UNITED STATES PATENT AND TRADEMARK OFFICE

APPLICATION NO.	FILING DATE	FIRST NAMED INVENTOR	ATTORNEY DOCKET NO.	CONFIRMATION NO.
09/865,601	05/29/2001	Yunzhi Gao	GAO 1	4139

Office Action Summary	Application No.	Applicant(s)
	09/865,601	GAO ET AL.
	Examiner	Art Unit
	Raymond Alejandro	1745

DETAILED ACTION

FIG. 1

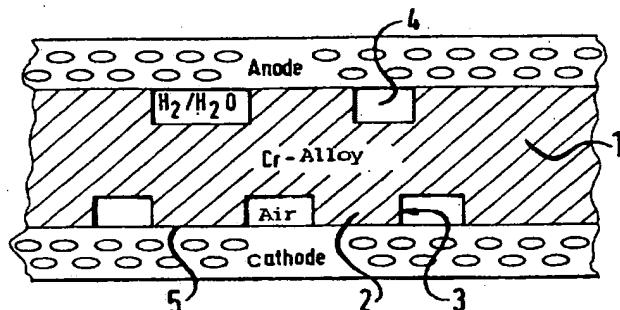
Figure 1 illustrates the bipolar plate (1) arranged between an anode and a cathode wherein the bipolar plate has channels (4).

FIG. 2

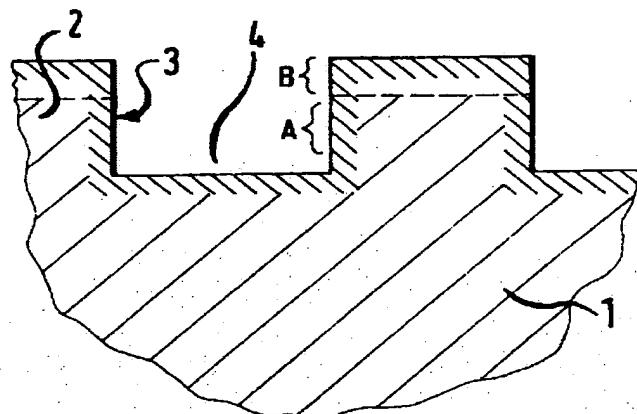
Figure 2 shows the ribs (2) and the side walls (3) of the gas channel (4); wherein A and B represent the Al-enriched layers.
